Report Type: Discussion

Questions/Concerns/Discussion

**Future updates on the Riverside Trail Project will be posted on the Town's website and PlaceSpeak page.**

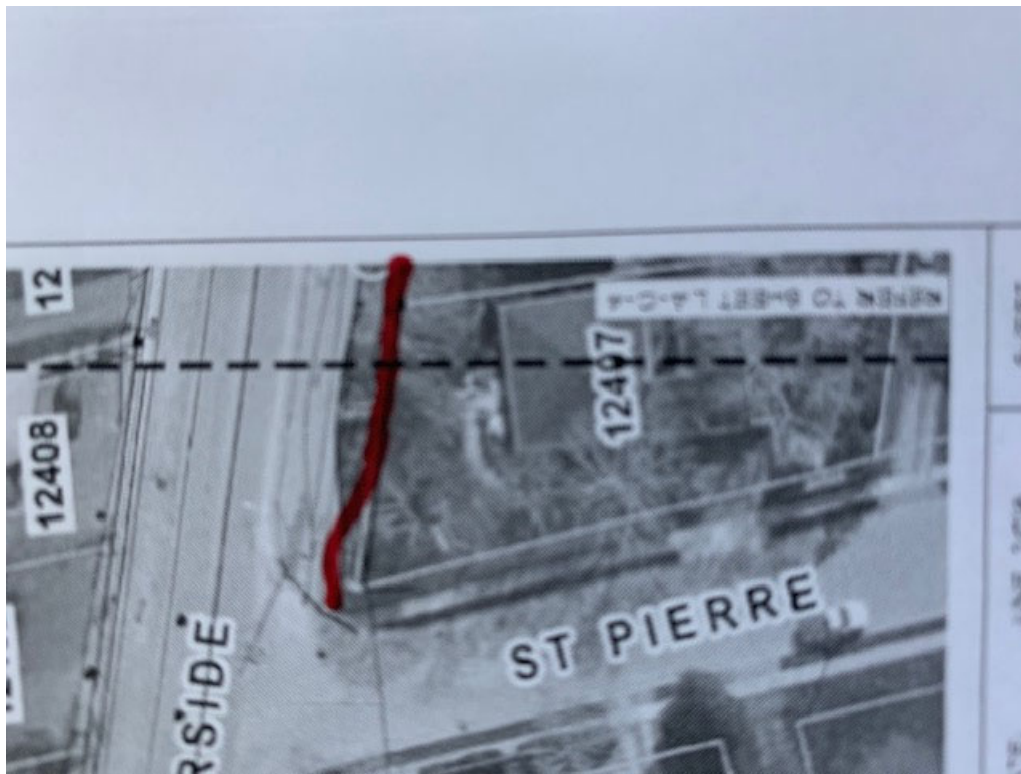
Here you have 2018 version. And then clearer view from 2021

Now they moved proposal completely inside sidewalk whereas their first rendition included sidewalk  
This occurs for a number of houses unfortunately  
They did not sufficiently address the change in position as Bezaire was one who created 2018 images  
Now the stone wall and tree is in jeopardy for us unlike when we had it installed and town rep told our installer  
that everything was on our property  
Entire undertaking is extremely frustrating

We would like clarity of the change in location and why we were told the landscaping was inside our property line  
and now it is not  
If you can assist with this it would be appreciated  
Regards  
Don

**From:** Mark Piche [REDACTED]  
**Sent:** May 7, 2021 4:32 PM  
**To:** Andrew Dowie; Phil Bartnik  
**Subject:** Todays 4 minutes of rain - photos attached (Mark Piche)

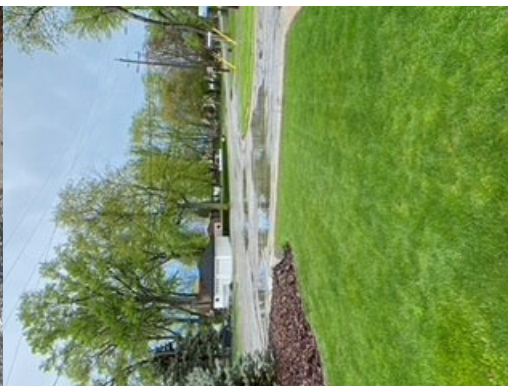
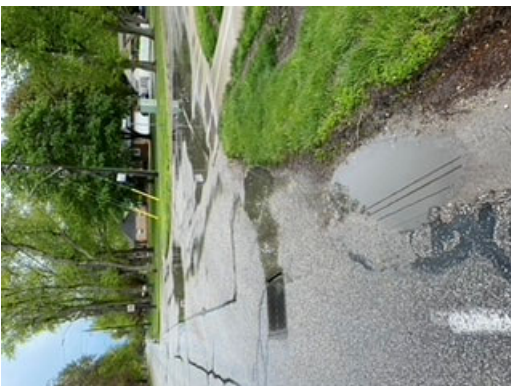
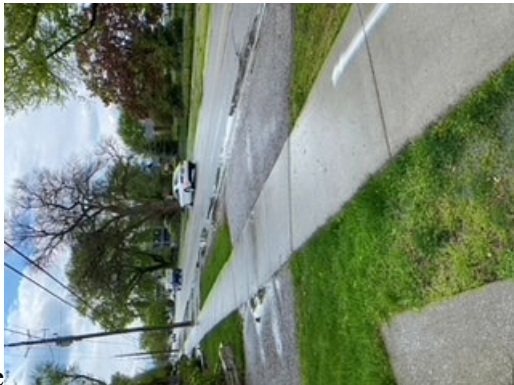
Respectfully, here is an example of 5 minutes of rain today where a trail is proposed. This is just one property.
